VCA 1 0V to 10V Linear CV Input 1 100K \*2,4,5 +12V ↑<sub>R3</sub> -1V to 10V Exponential CV Input 1 120K - 33K C1 \*2,3 R4 1nF C2 1K 100pF GND U1A R5 AS3330 51K 10Vpp R6 Signal Input 1 100K SigIn1 Signal Output 1 TL072 GND С3 5nF  $\dot{\uparrow}$  $\Diamond$ GND GND

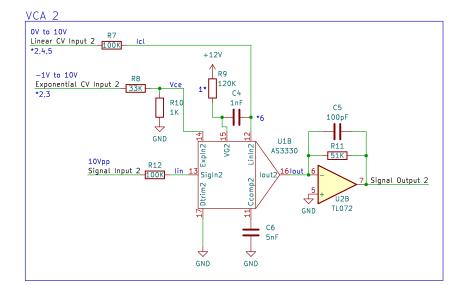
10V at the linear control input through the 100K resistor will be at unity gain. OV would be at -80dB?

-10V would be at max attenuation which is -110dB
